Re: Westside Skate Park Phase 1, 6900 Gonzales Road SW, Site Development Plan

Engineer's Stamp dated 8-08-05 (L10-D13A)

DRAINAGE AND TRANSPORTATION INFORMATION SHEET

PROJECT TITLE: Westside Skate Park, Phase 1 ZONE MAP/DRG. FILE#: K and L 11 Z L-10/D13A

Westside Skatepark - Trapezoidal Weir Calculation Worksheet for Sharp Crested Cipolletti Weir

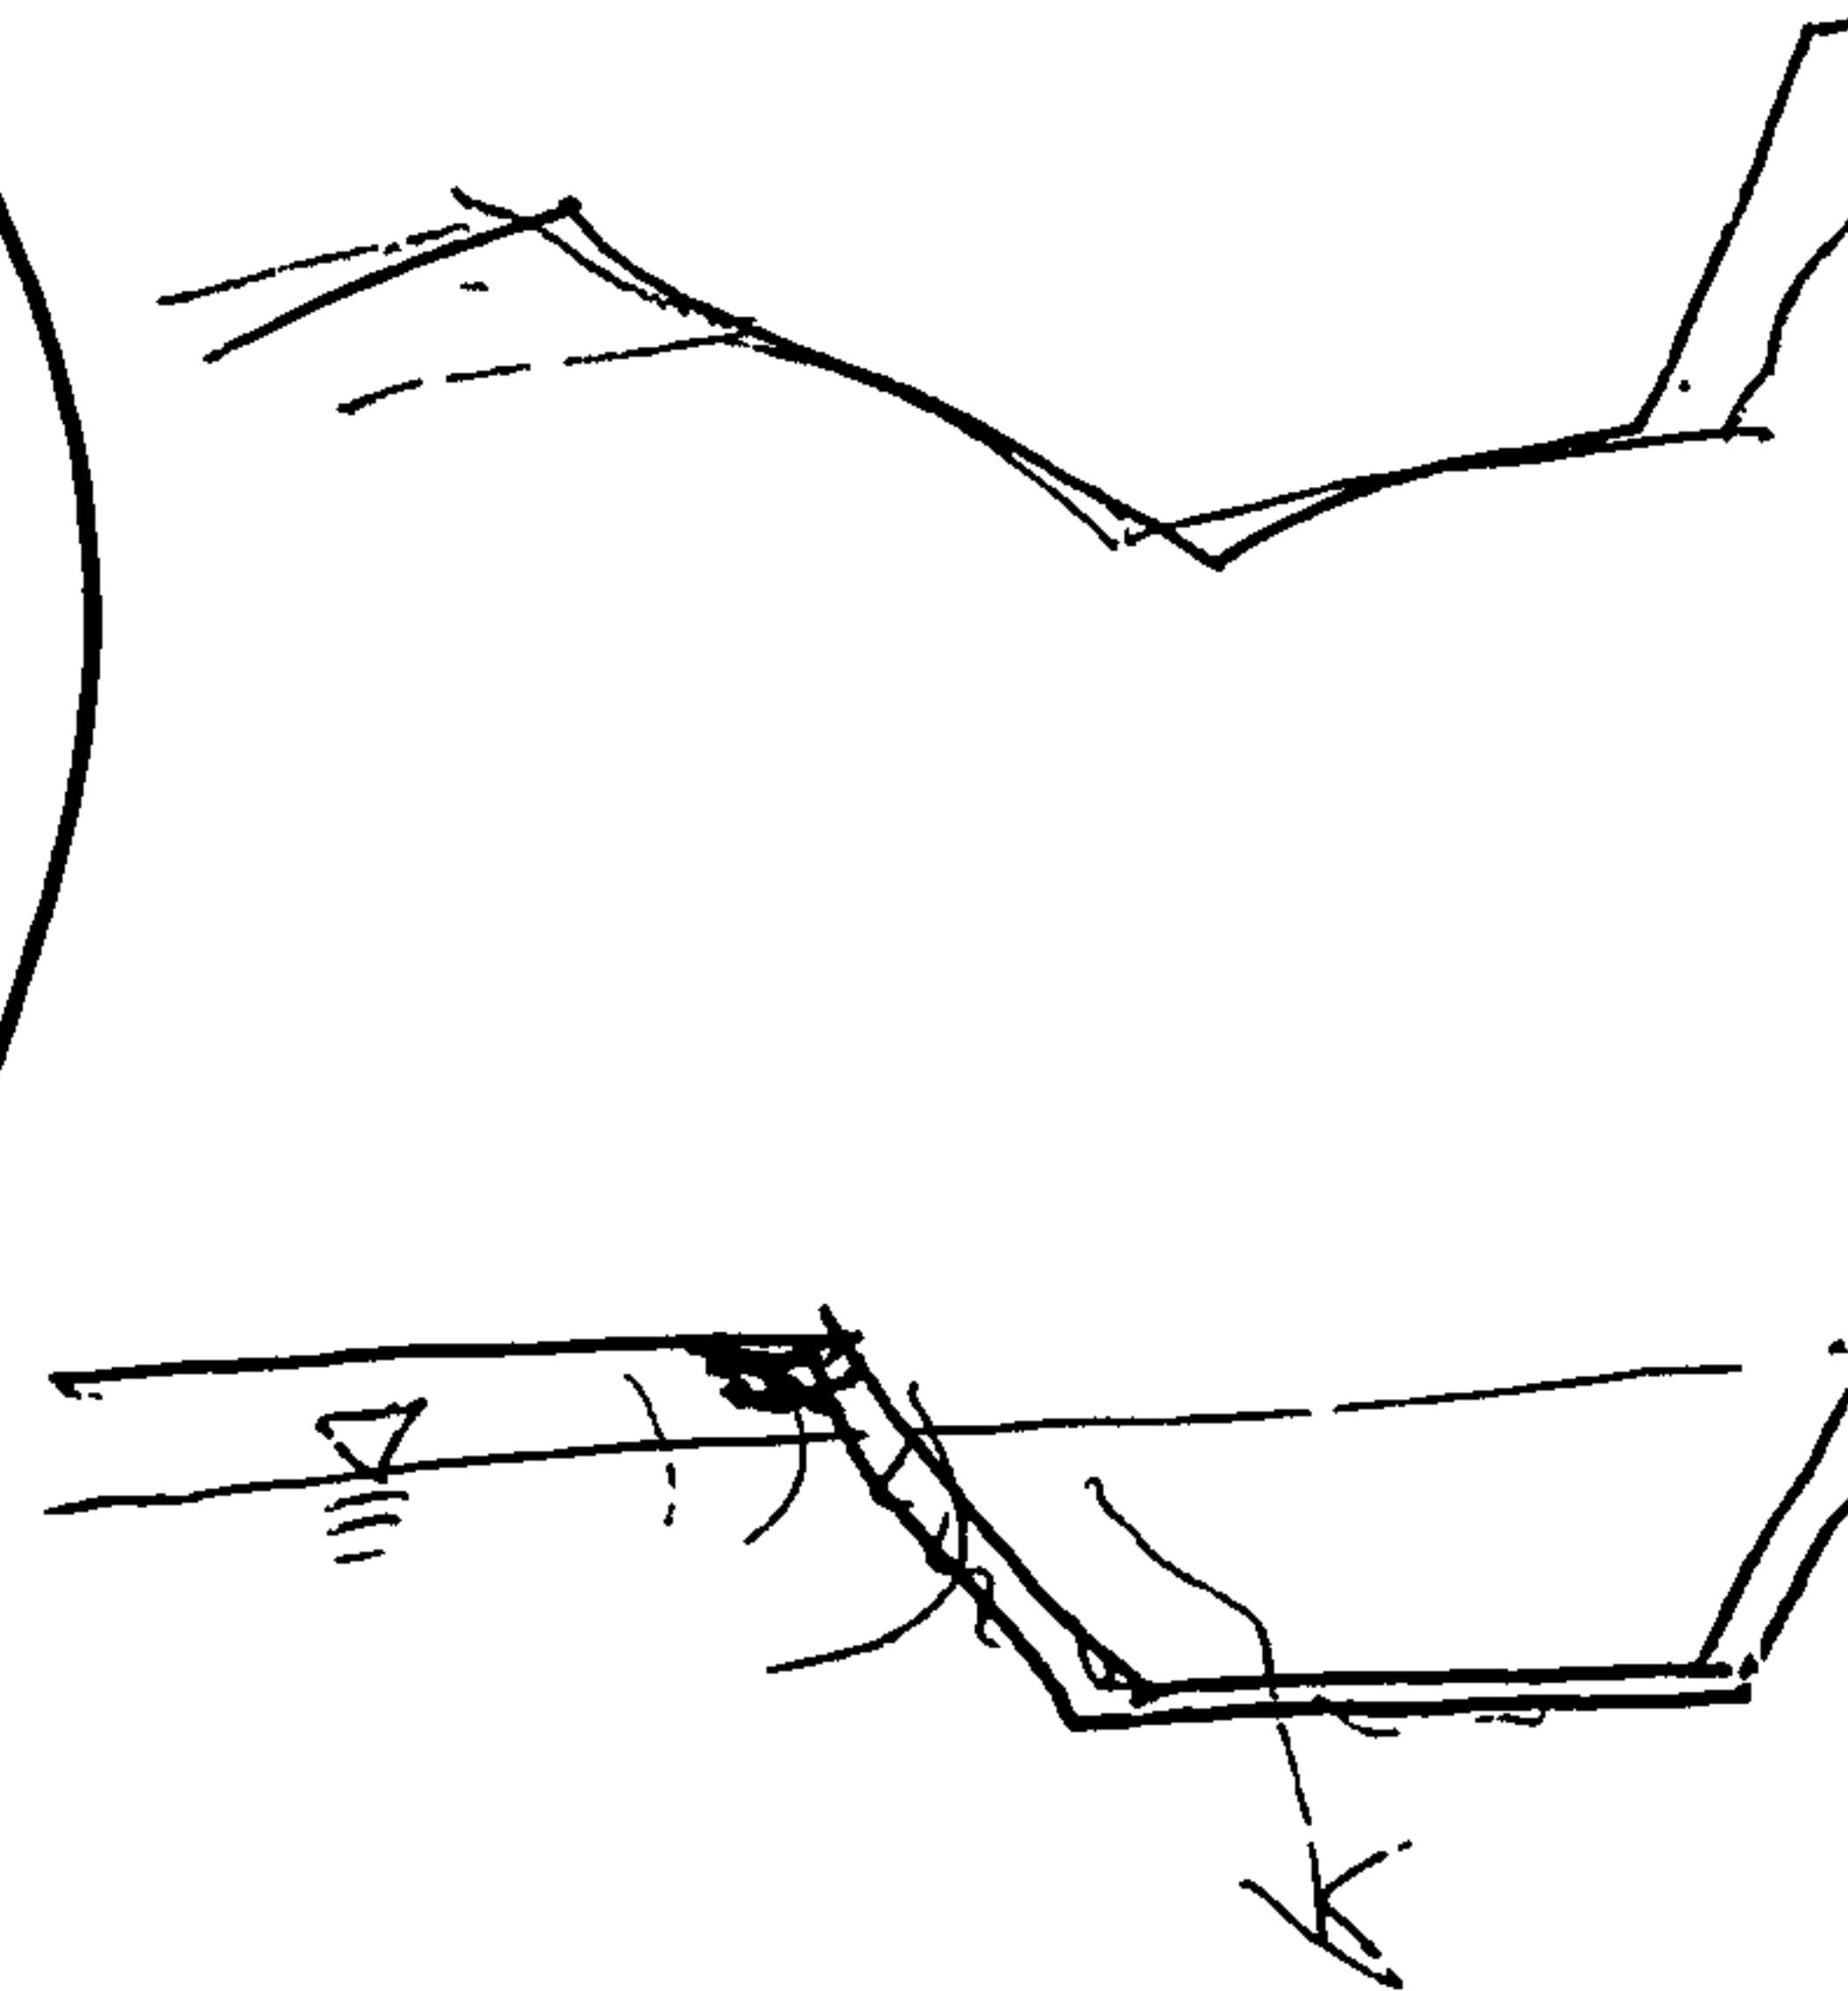
← Usually $C = 3.367$

← $Q_{\text{allowed}} = 3.2 \text{ cfs}$

Why not calculating
for a broad weir?
According to plan,

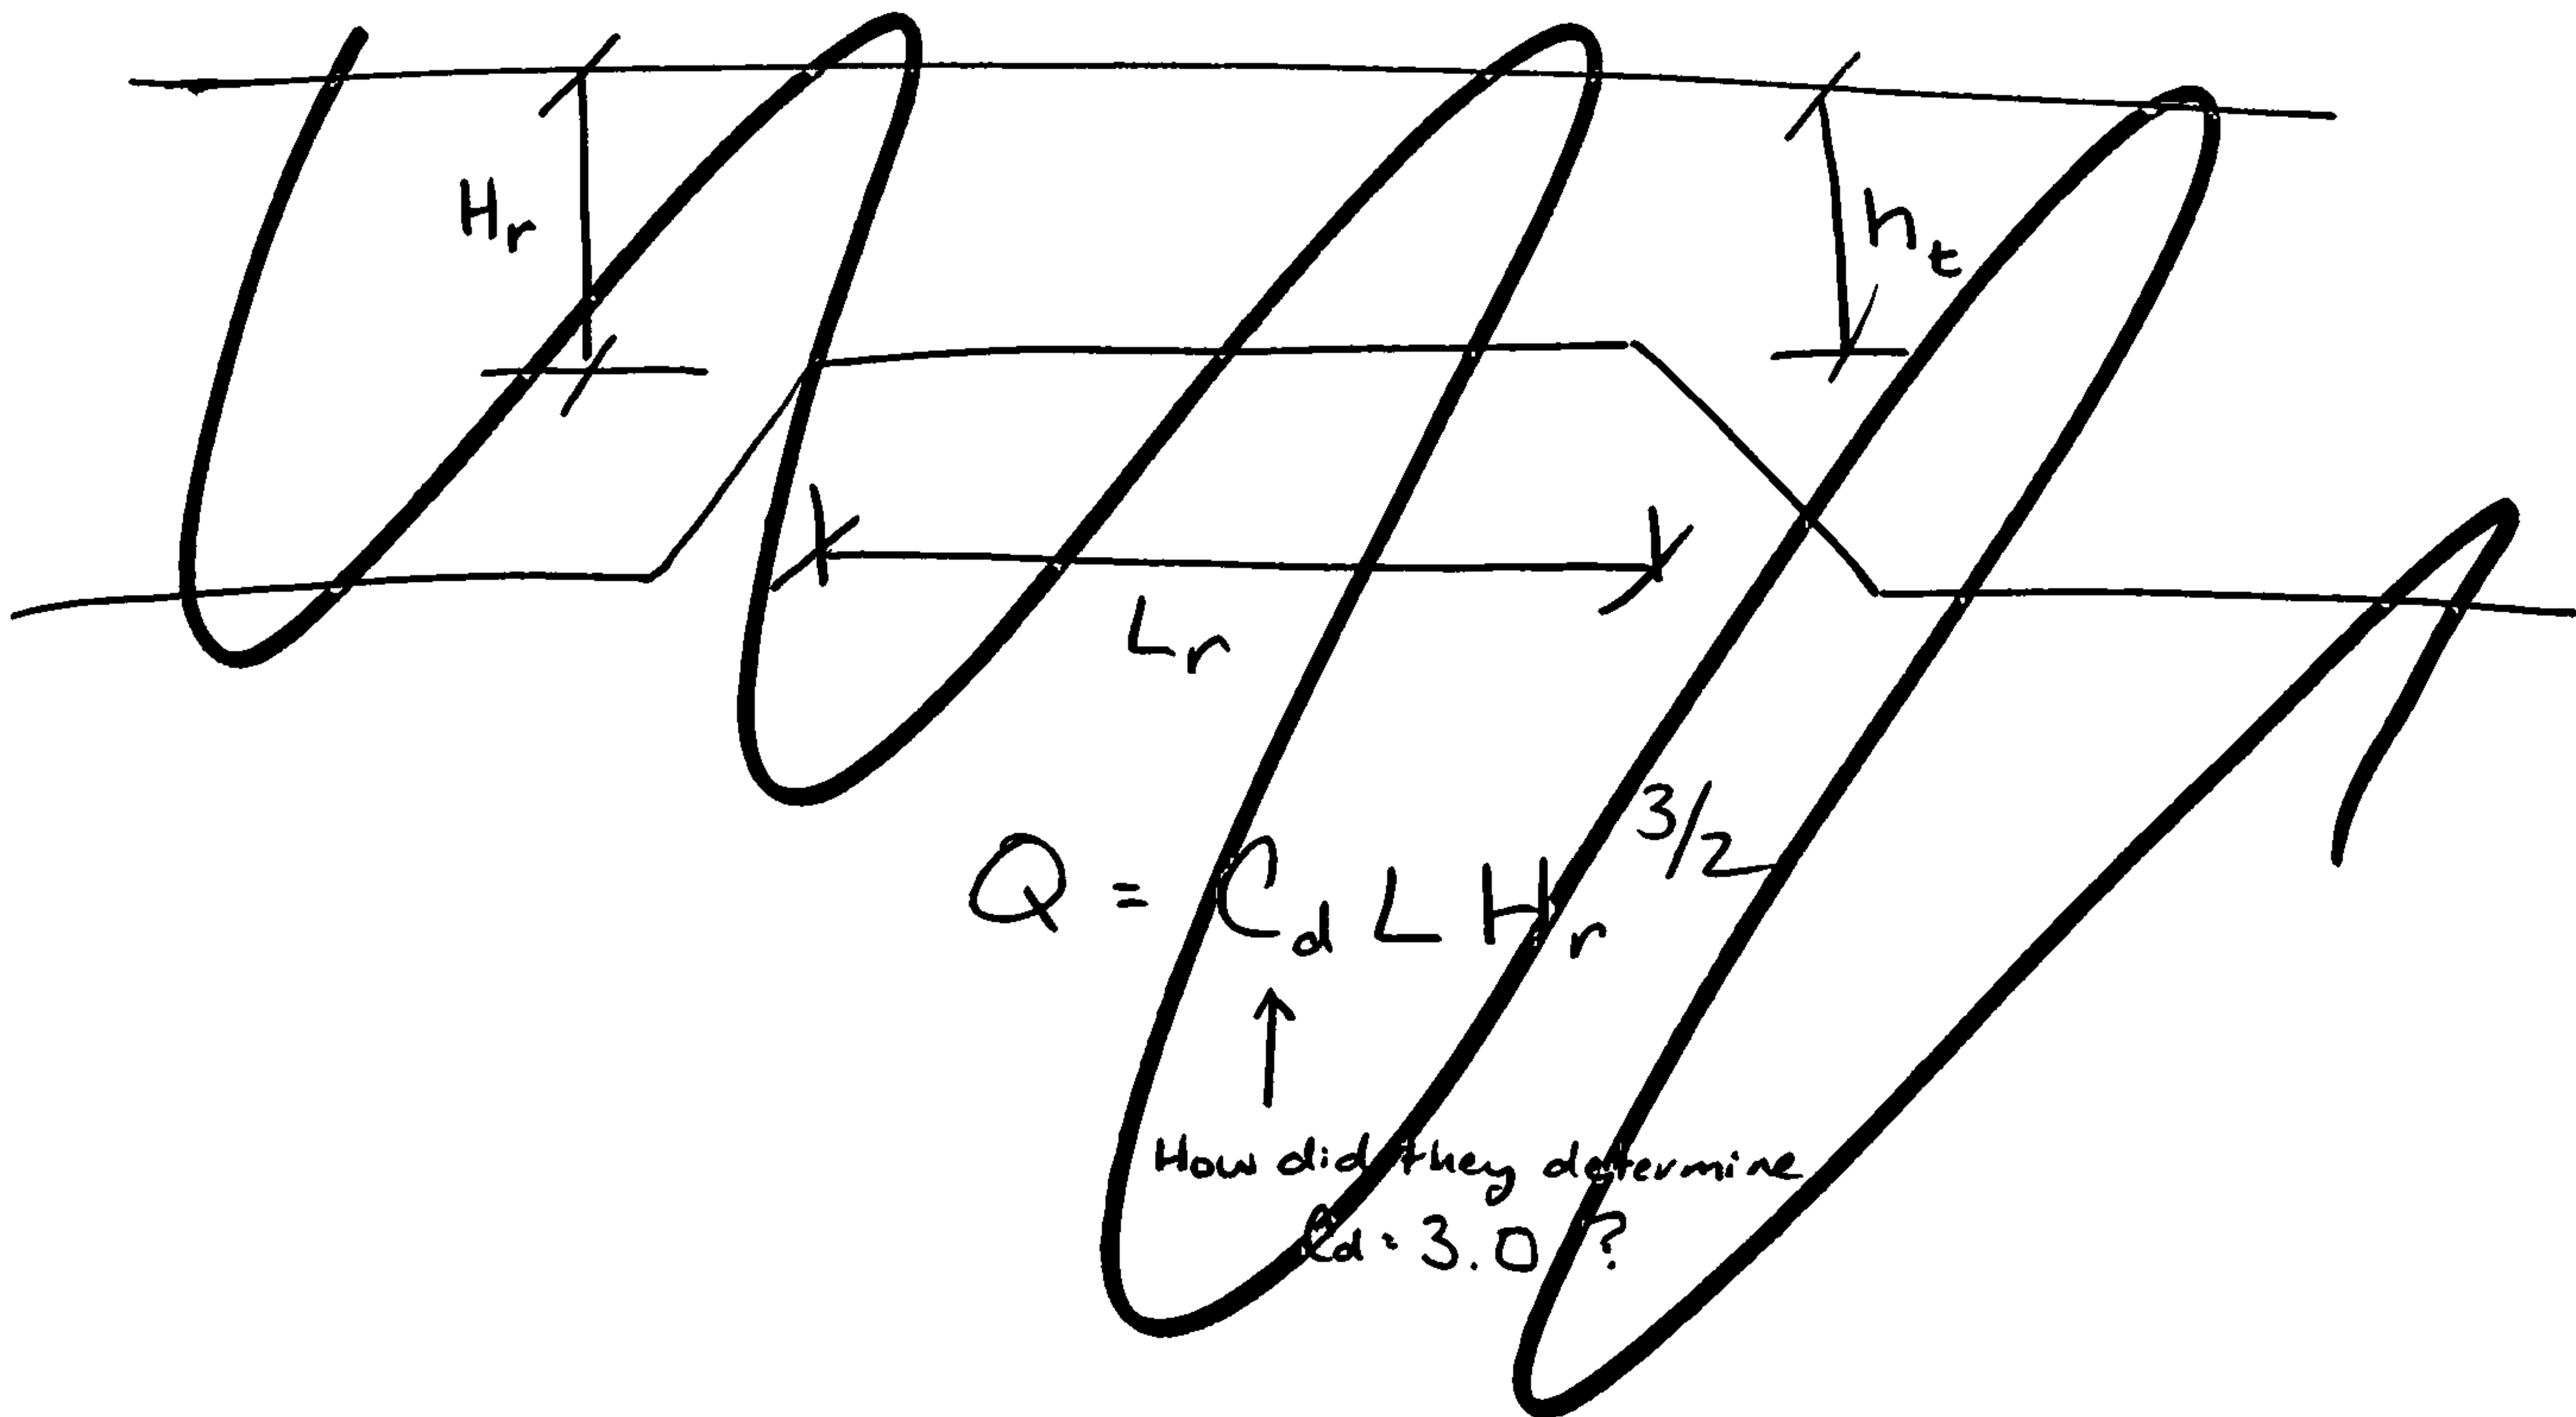
↑
How did they determine
 $C_d = 3.0$?
